City of Alexandria, Virginia

SUBJECT: HOFFMAN BLOCK 8 – UPDATE TO THE STAFF REPORT

Hoffman Town Center – Block 8
Master Plan Amendment #2011-0005
CDD Concept Plan CDD #2011-0004
Development Special Use Permit #2011-0020
Transportation Management Plan SUP#2011-0046

MPA #2011-0005
DSUP #2011-0020
CDD CONCEPT PLAN #2011-0004
SUP TMP #2011-0046

Original Eisenhower Avenue Elevation

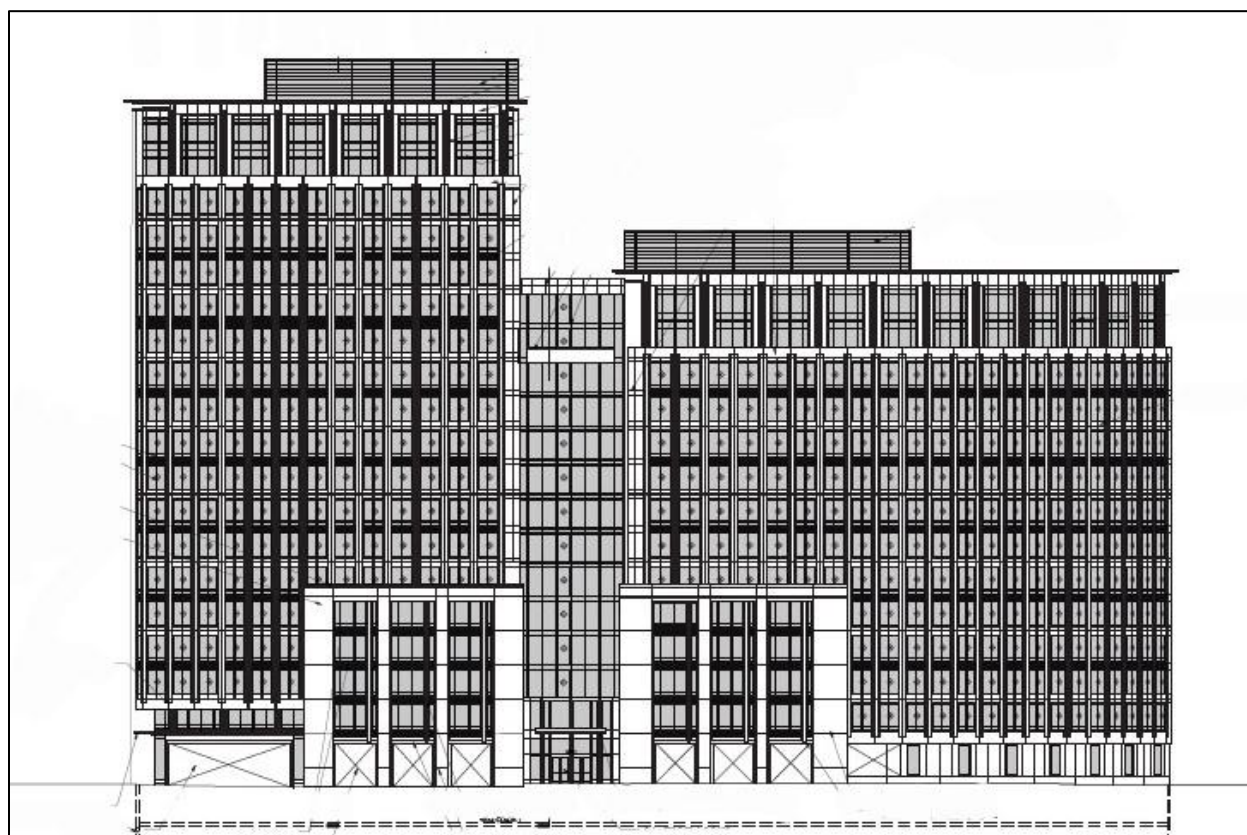
Staff also supports the vertical extension of the atrium component. With this revision, the space between the two towers would be occupied by office floor area and the floor plates between the two towers would be connected. While this does not provide the separation of the towers that occurred in the original proposal, this change is necessary to accommodate the GSA tenant since it provides the additional floor area and internal connections that the two separate towers do not. The atrium component is inset between the two towers along the Eisenhower Avenue frontage approximately 25 feet from the eastern tower and approximately 55 feet from the western tower. This recess and the designed offset of the two towers provide a visual separation. Furthermore, the applicant has proposed using spandrel glass for the stories added above the atrium in order to differentiate this recessed area from the two towers and make it more of a background element. The use of precast along the sides of the towers further delineates the extent of the towers.
